**CITY OF CALLAWAY
JAN DR. & GENEVIEVE AVE.
DRAINAGE IMPROVEMENTS
BID NO: PW2022-13**

ADDENDUM #2

Date Issued: July 26, 2022

LATERAL PAVEMENT PATCH DETAIL

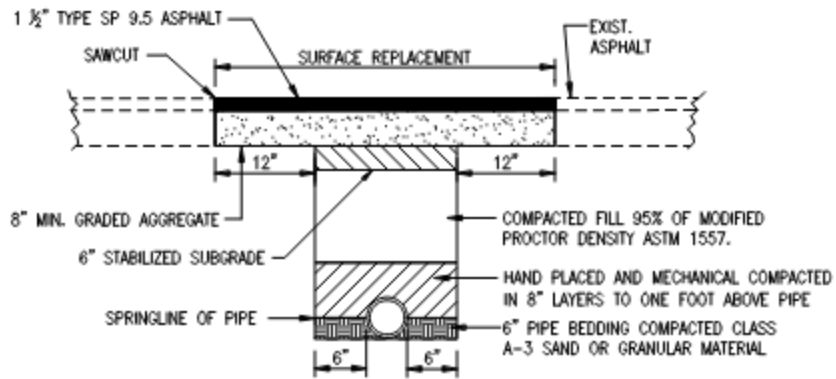
This addendum is being released to provide asphalt pavement patch detail as attached.

GRADED AGGREGATE BASE LAYER SHALL BE COMPACTED TO 100% MODIFIED PROCTOR DENSITY AASHTO T-180. BACKFILL BELOW BASE LAYER WILL BE PLACED IN MAXIMUM 8-INCH THICK LOOSE LIFTS.
